RULE NO.: R161-23.16

NOTICE OF RULE ADOPTION

R161-23.16: Modifies the Drainage Criteria Manual as follows:

Figure 5-3

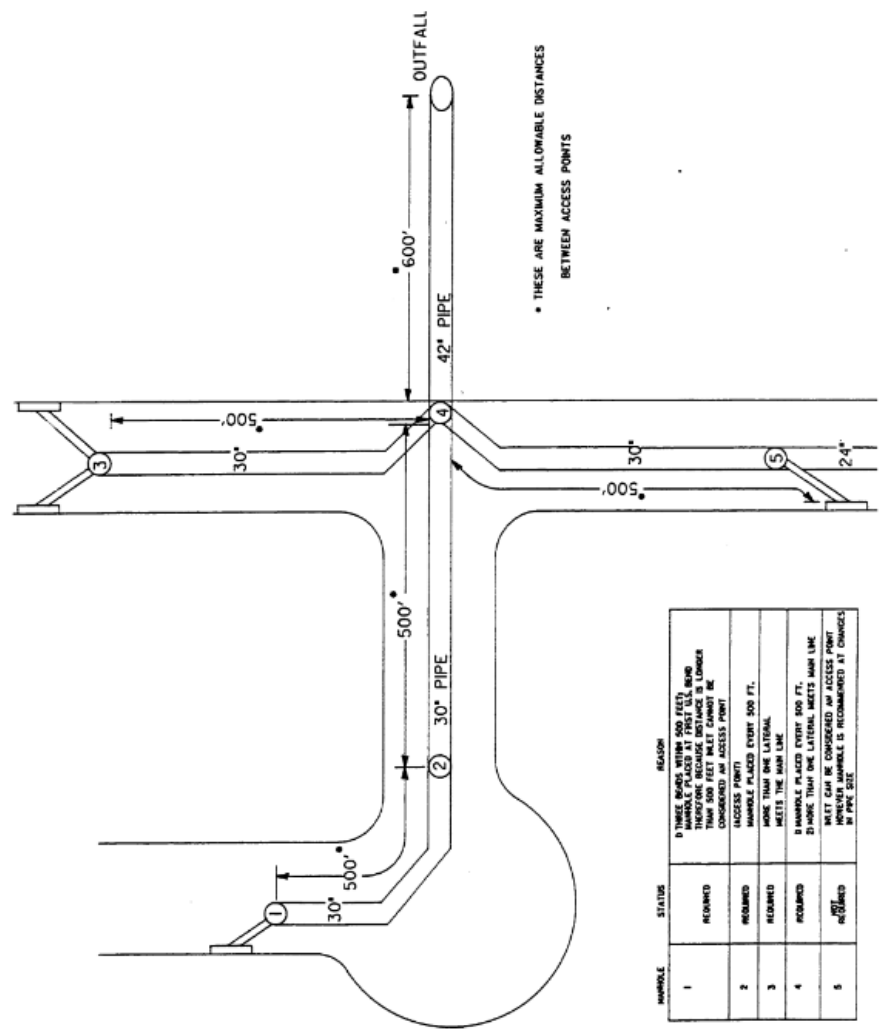
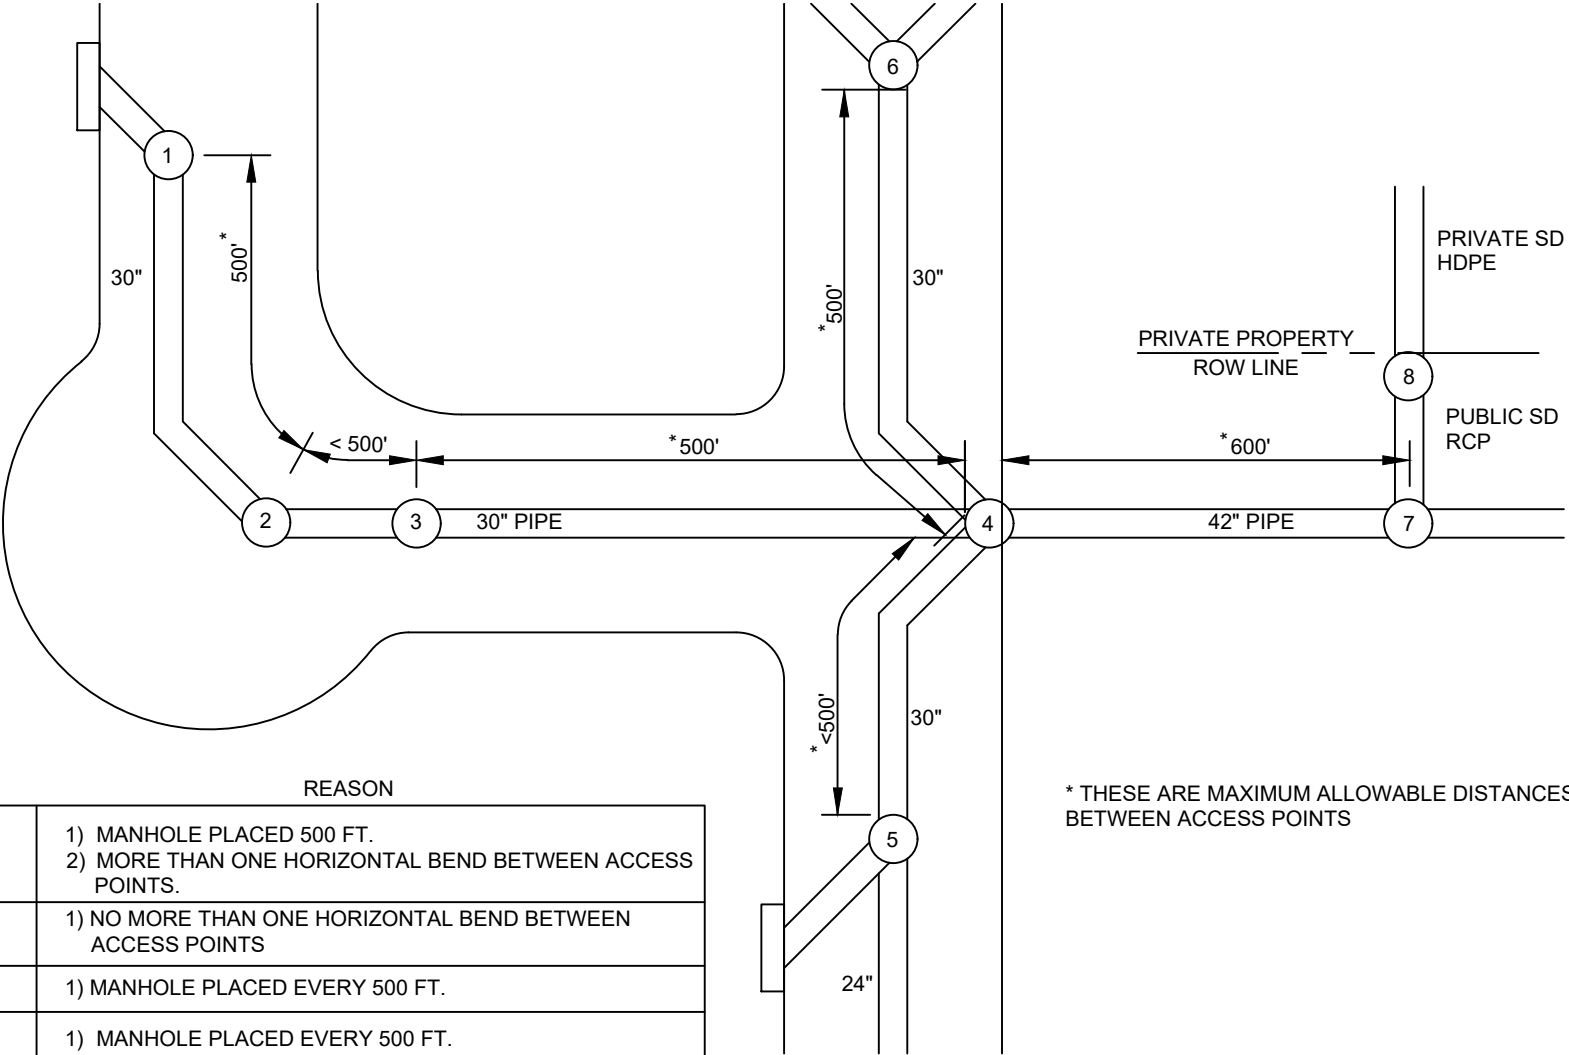
- 1.2.2 - General The changes address incorrect figure references, fix grammar and spelling errors, and clarify RSMP existing participation requirements per DCM 1.2.2.G. These proposed updates do not change program eligibility or add any restrictions.
- Appendix D Figure 5-3 Updates the figure regarding the number of bends between access points. The proposed updates do not change current criteria, but rather adjusts the figure to enhance clarity.

Manholes shall also be located where two or more laterals intersect the main line within five (5) feet of each other (See Figure 5-123 in Appendix D of this manual for examples of possible manhole locations). Manholes shall also be placed at locations where changes in pipe size occur.
